AIR RESOURCES BOARD

Executive Order G-70-36-C

Relating to the Modification of the Certification of the
OPW Balance Phase II Vapor Recovery System
for Service Stations

EXHIBIT 4

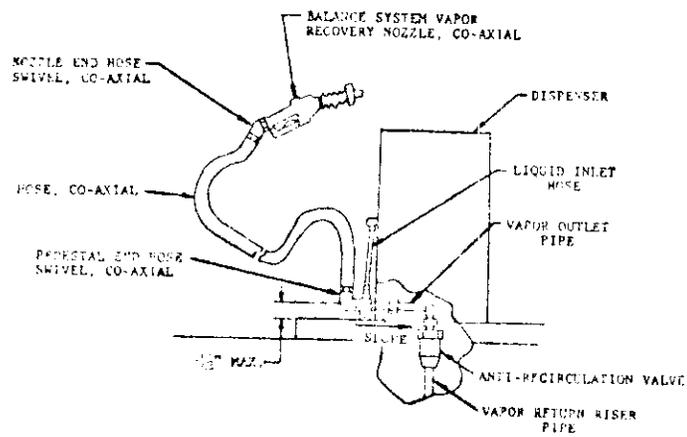
1. Include the B.F. Goodrich co-axial hose assembly, described in Exhibits 4 and 5, as an alternate hose configuration, and
2. To include the OPW-11VC slim handle nozzle as an alternate nozzle for the OPW-7VC.
